**RE: Santa Barbara Subdivision Replat of Lot 2 Block 16
Grading & Drainage Plan
Engineer's Stamp Date: 04/22/22
Hydrology File: D19D001F**

Based upon the information provided in your submittal received 04/29/2022, the Grading & Drainage Plan is **not** approved for Grading Permit and for action by the DRB on Preliminary Plat. The following comments need to be addressed for approval of the above referenced project:

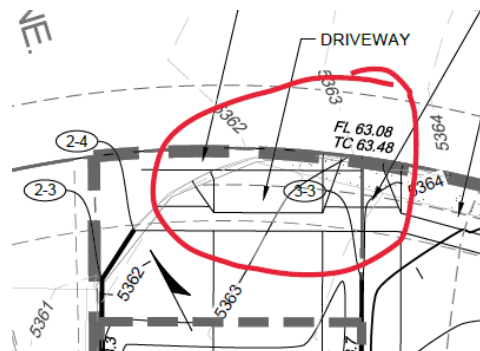
- Typically, the drive pad cannot be built on a radius. Please consult Transportation Section.

This problem can be solved with extending the curb & gutter along the property line and then have a smaller radius after the drive pad as shown below.

CITY OF ALBUQUERQUE	
	DEPARTMENT OF MUNICIPAL DEVELOPMENT	
	ENGINEERING DIVISION	
	SANTA BARBARA IMPROVEMENTS	
GRADING AND DRAINAGE PLAN		ZONE MAP NO.
DESIGN REVIEW COMMITTEE		CITY ENGINEER APPROVAL
CITY PROJECT NO.		NA
SHEET NO.		1 of 2

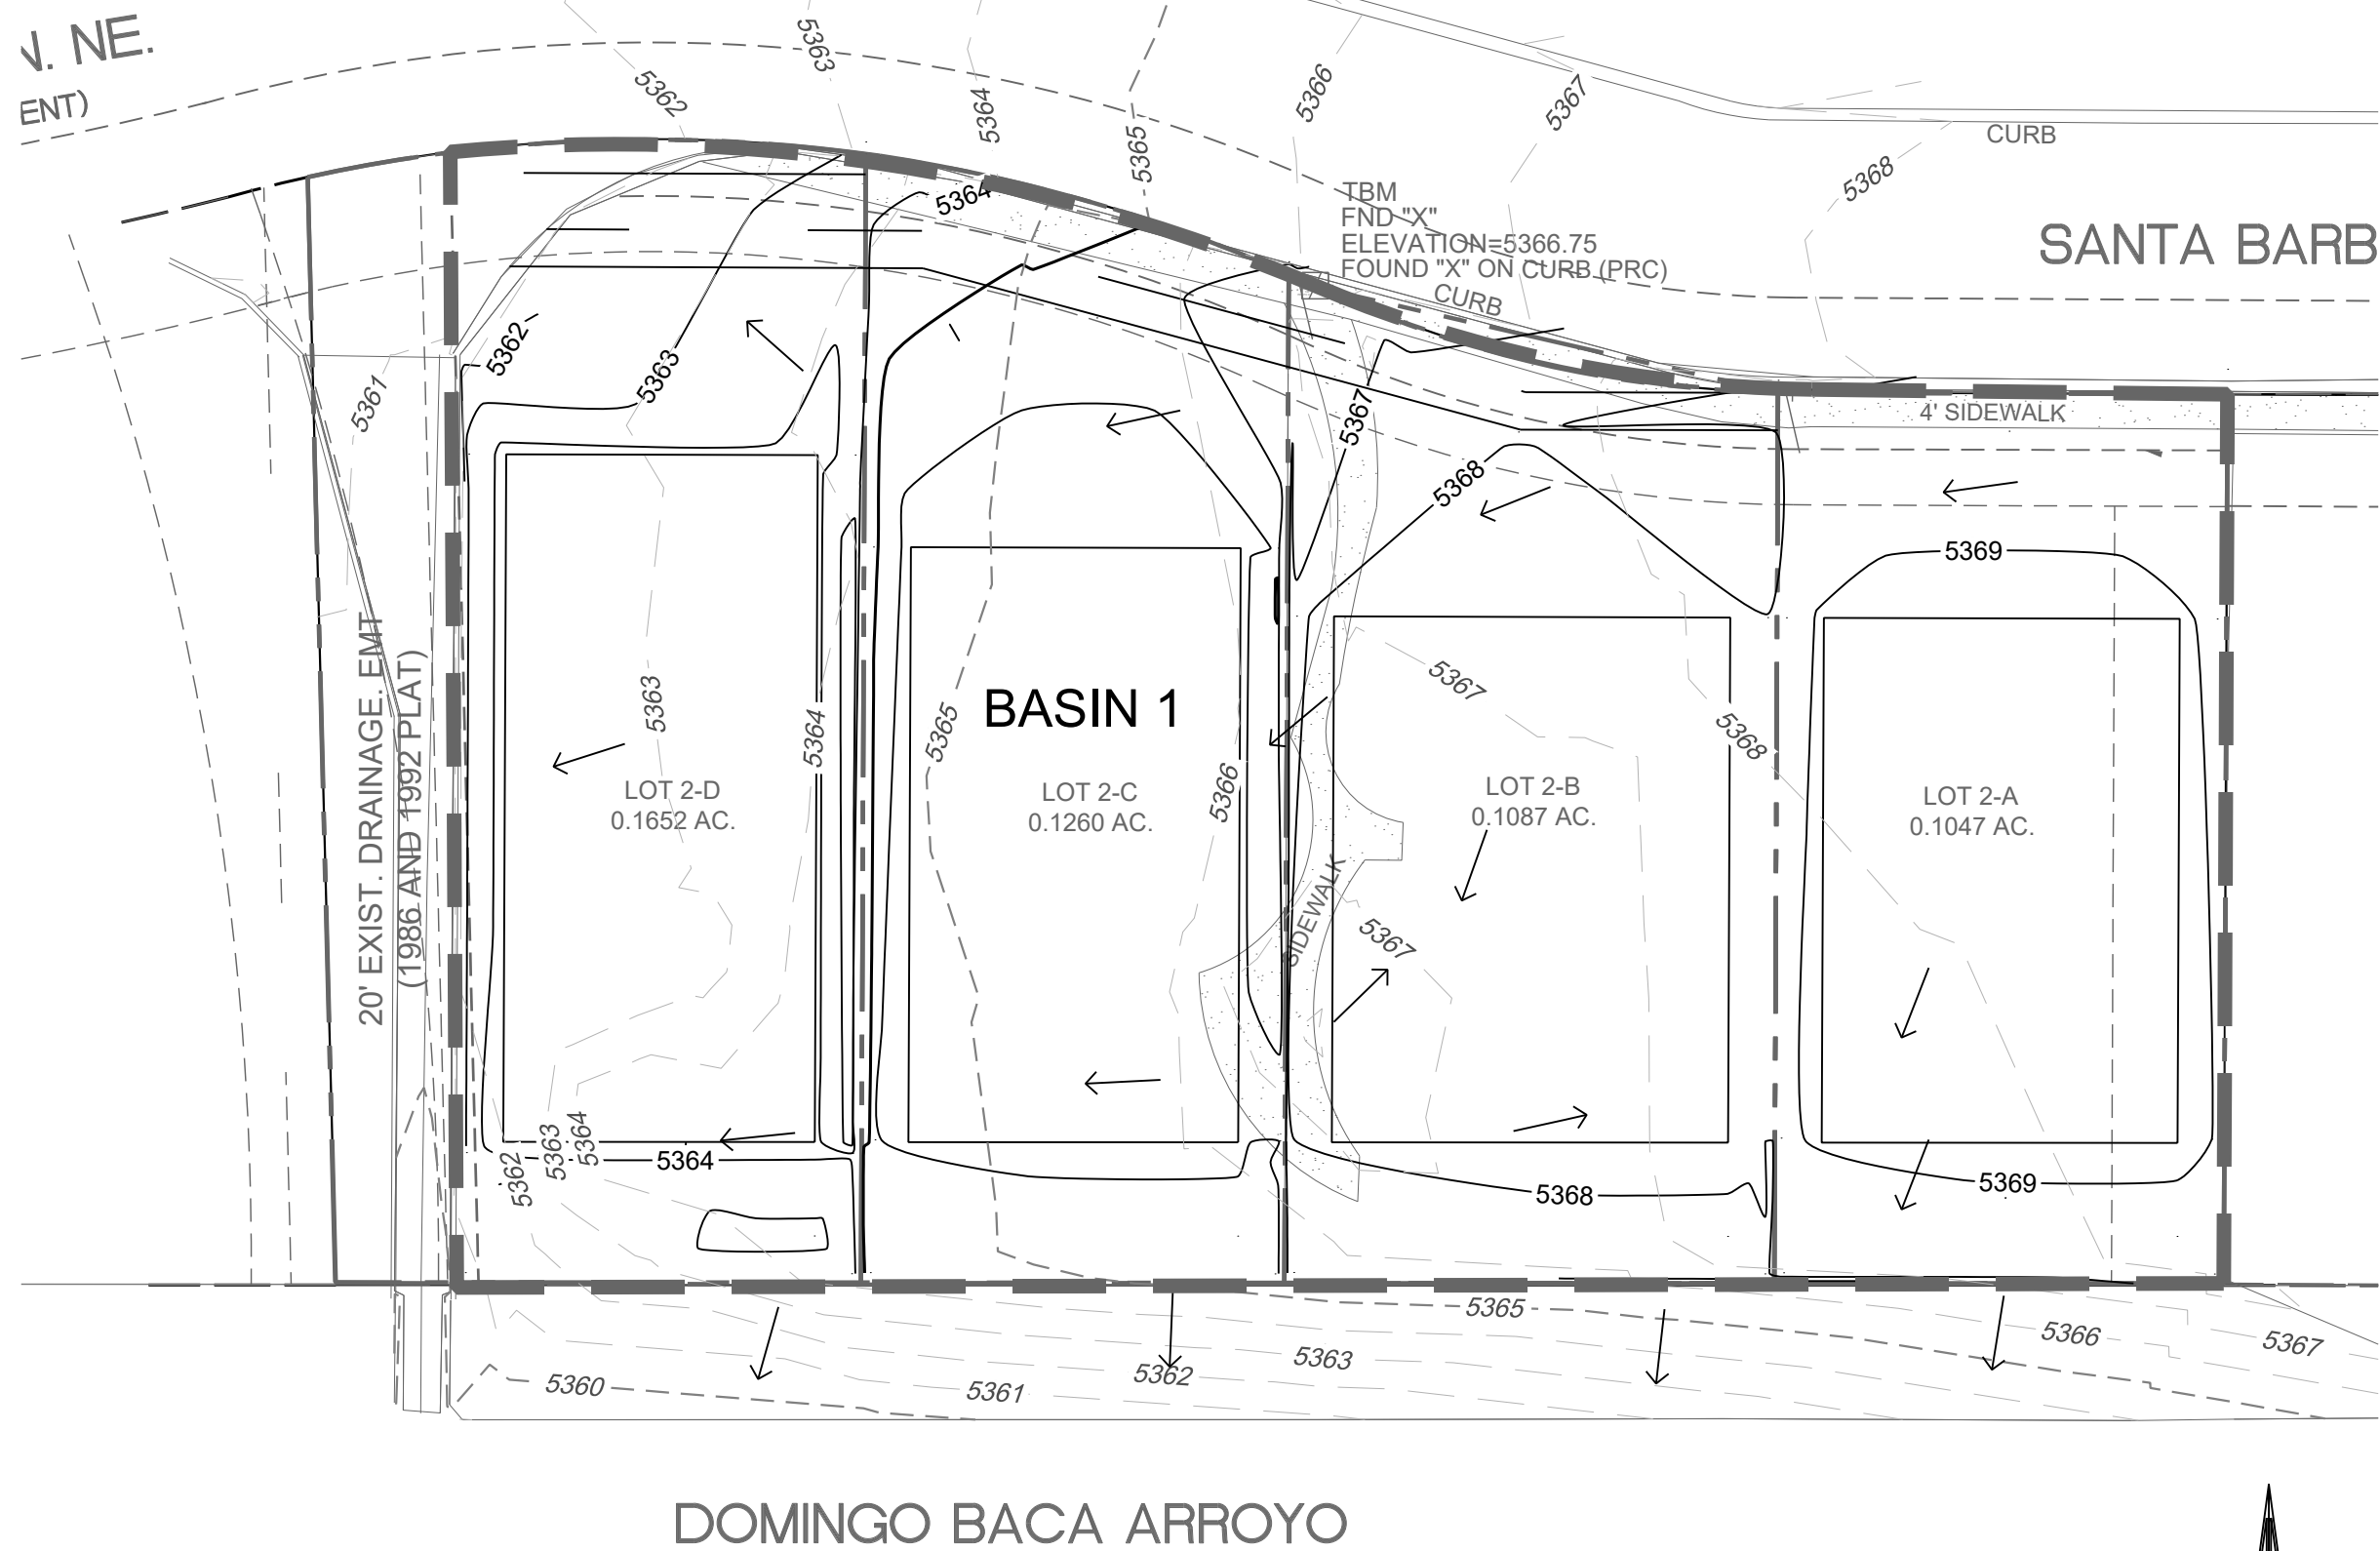
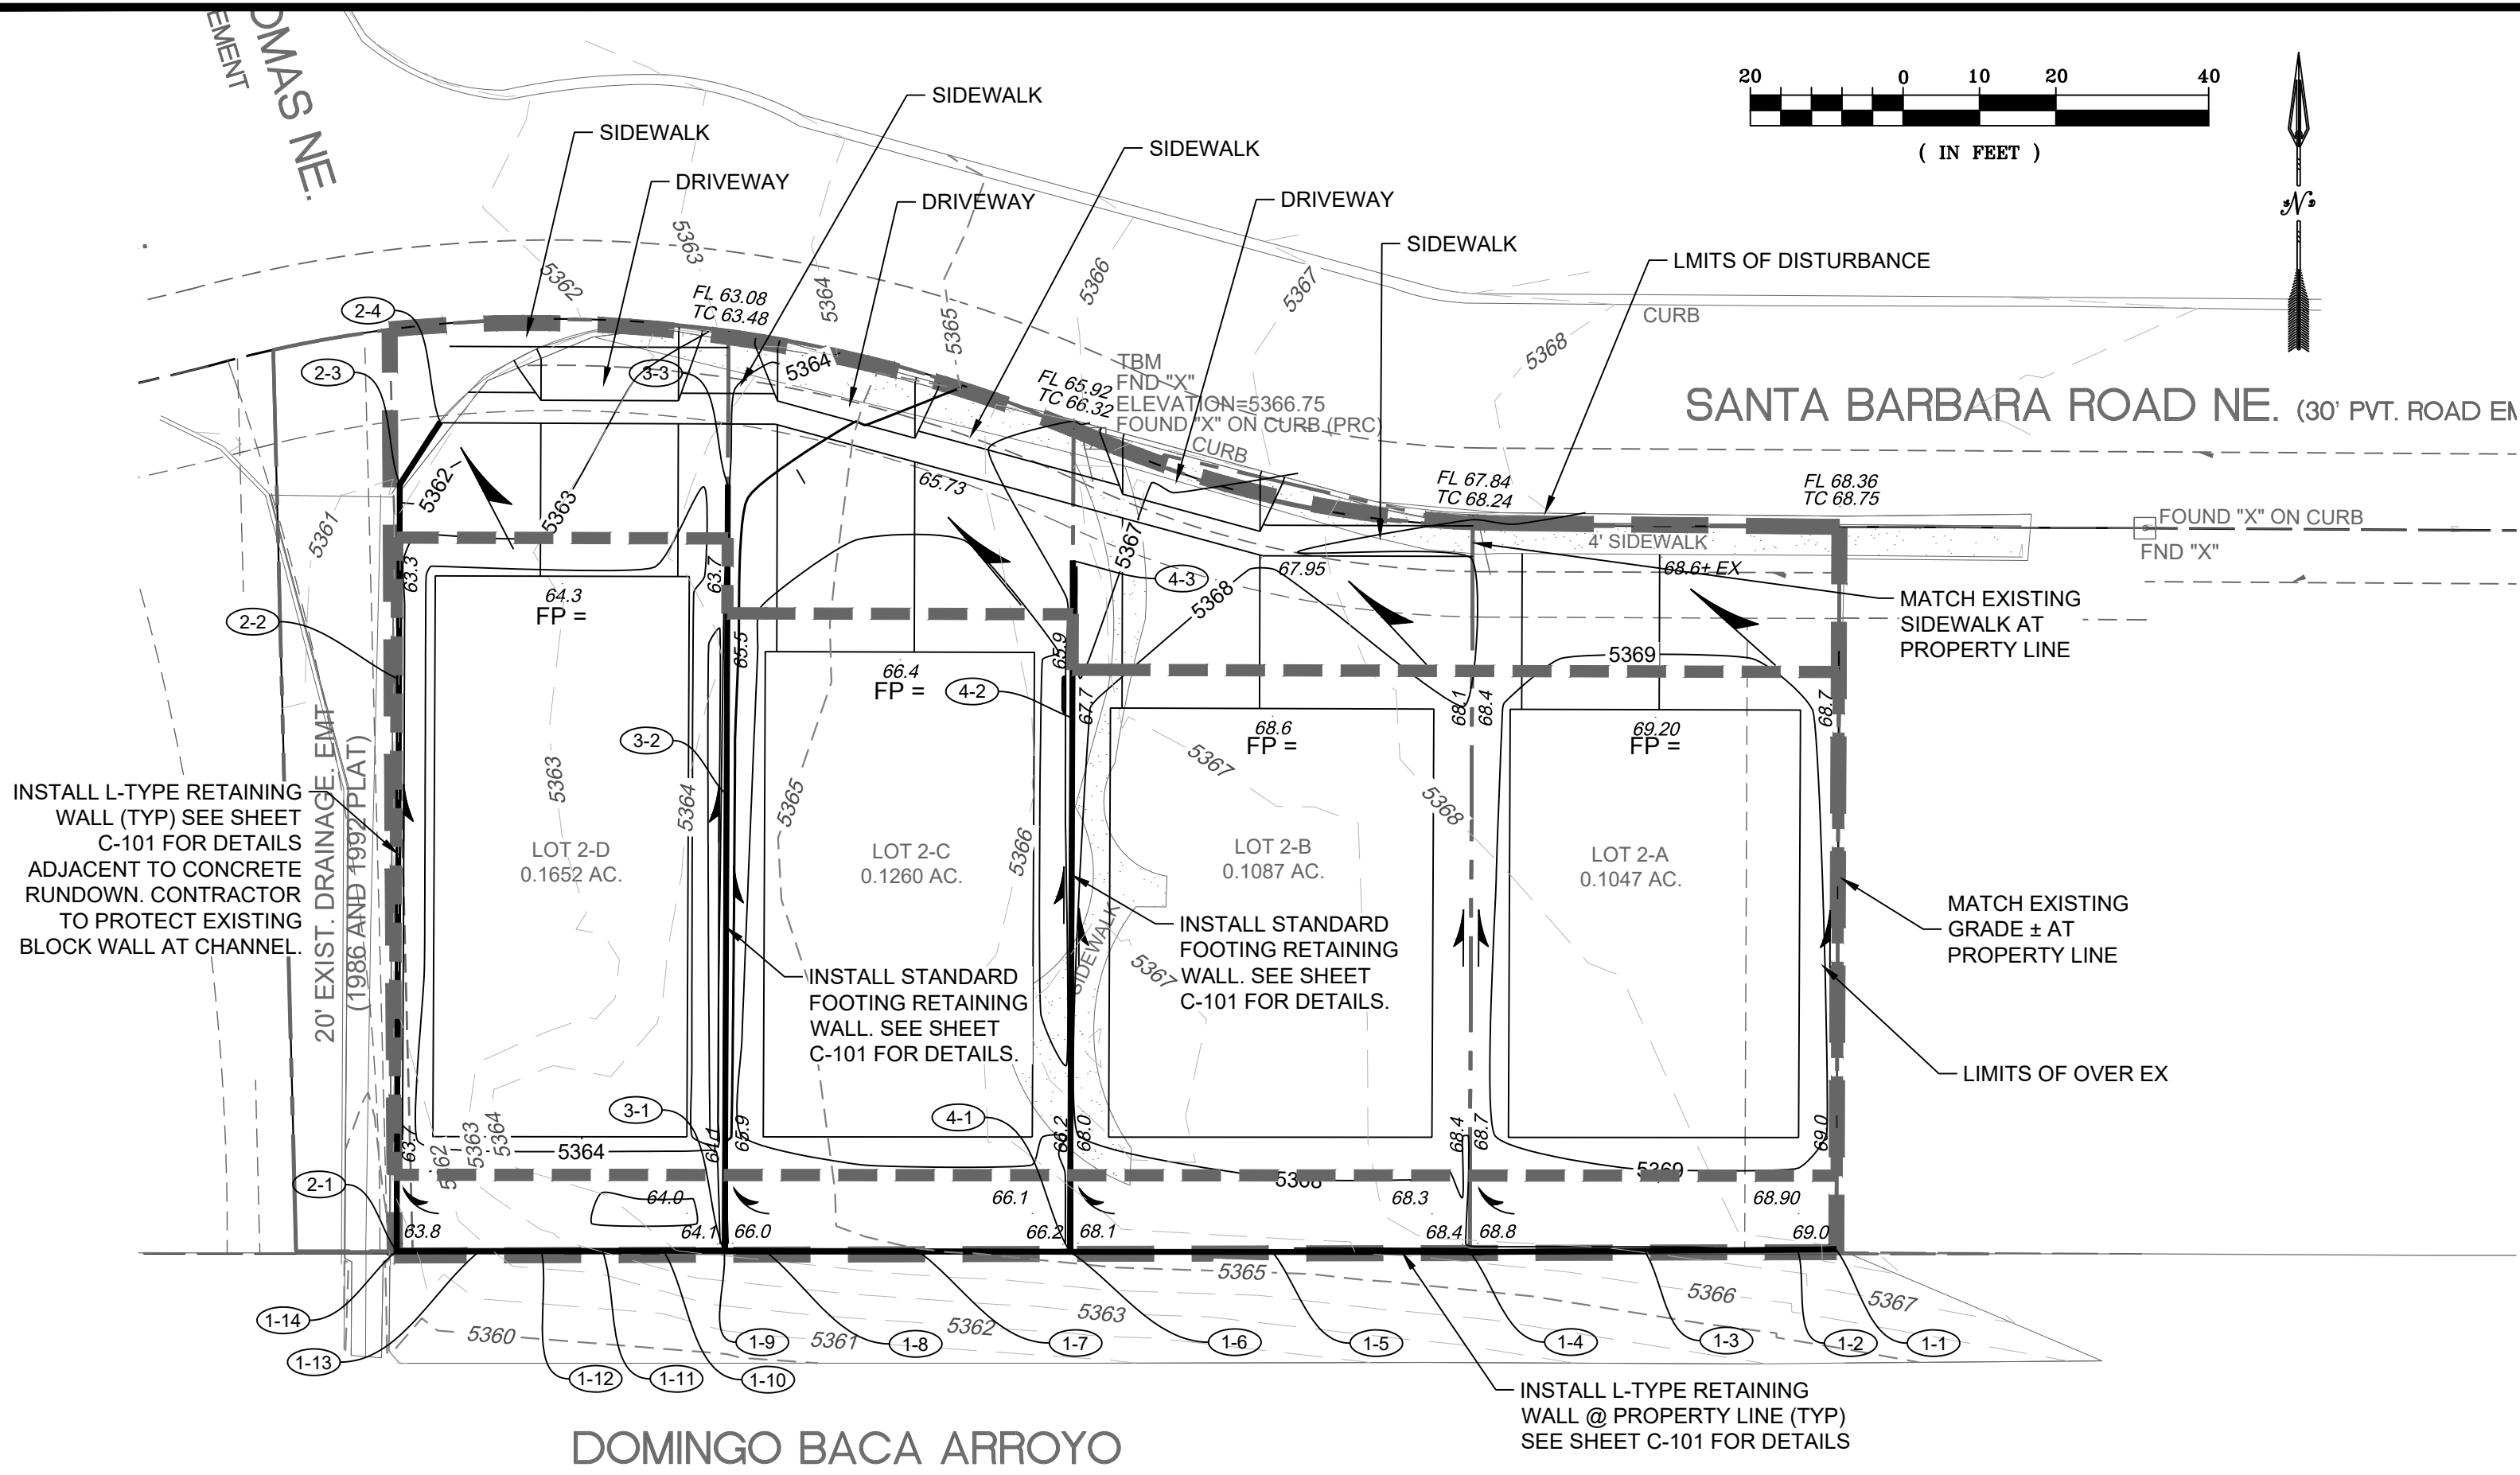
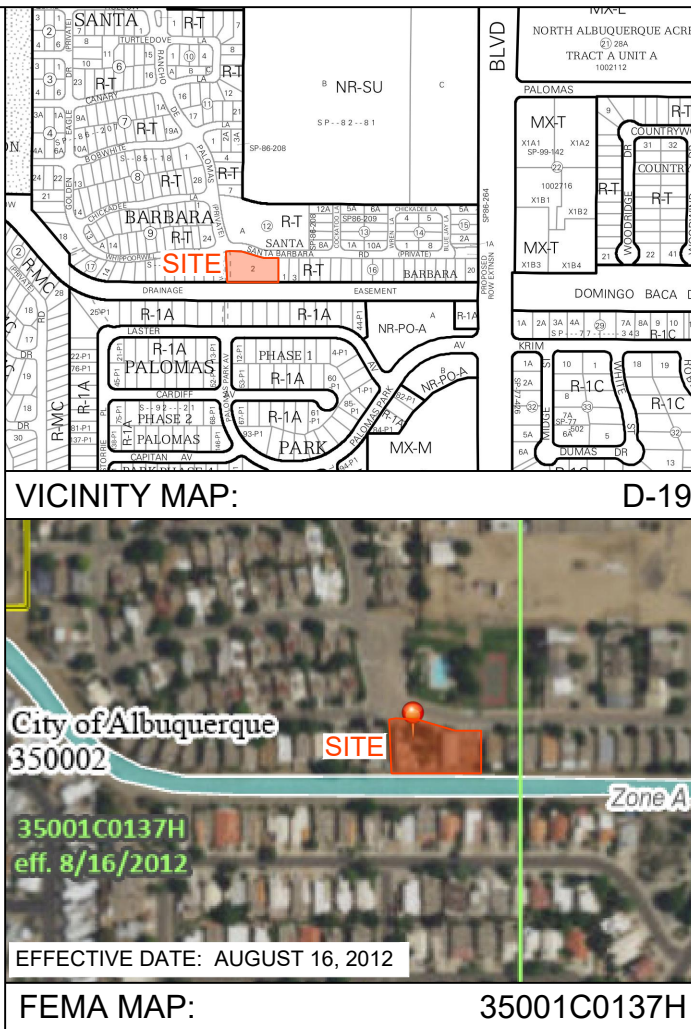
1. Under the Background. Please fix the Block information. This is Block 16 and not Block 17.
2. Under the Methodology. Please refer to Article 6-2(a) of the Development Process Manual (DPM) and not Chapter 22 (this was the old DPM).

3. Please use the procedure for 40 acre and smaller basins as outlined in Development Process Manual (DPM) Article 6-2(a). Please provide both the existing conditions and proposed conditions for the 100 year-6 hour storm event.

4. Please also include the existing and proposed calculations for the existing concrete channel. Please use the entire watershed that goes into this channel. This being said, an aerial can be used to show the extent of the watershed. I want to ensure that the concrete channel will be able to handle the change from what is there now and when the lot is converted to townhomes.

5. The existing 20' Private Drainage Easement which has the existing concrete channel needs to be converted to Tract A which is owned and maintained by the HOA. This easement should not be part of Lot 2-D.
